Date: September 9, 2026
To: Cambridge Planning Board
From: Cambridge Bicycle Committee
Re HealthPeak proposed PUD in Alewife

After viewing HealthPeak's presentation to the Cambridge Joint Meeting of the Transportation Committees in July 2026, the Cambridge Bicycle Committee, an advisory committee to the City Manager, is submitting these recommendations to the Planning Board.

Exhibit 1 - Complete streets design, as presented by Health Peak

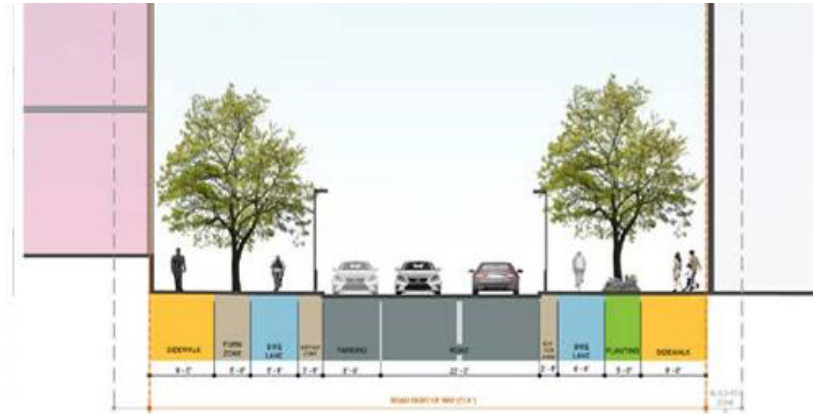
The Bicycle Committee generally supports the transportation plan envisioned for the PUD area. We support the complete streets approach as presented, with raised separated bicycle lanes, and a vegetation buffer between the bike lanes and pedestrian sidewalks, on both Smith Place and on Fawcett Street (see the sketch from the HealthPeak presentation, Exhibit 1 below.) We would recommend that this approach be extended to all major streets within the PUD. We also look positively on the PUD design taking into account bicycle and pedestrian connections from both the Smith Place and Fawcett Street intersections with Concord Ave. to portions of Alewife beyond the railroad tracks on the north side of the development. And very importantly, we are delighted to see the inclusion of a bicycle and pedestrian overpass over the tracks.
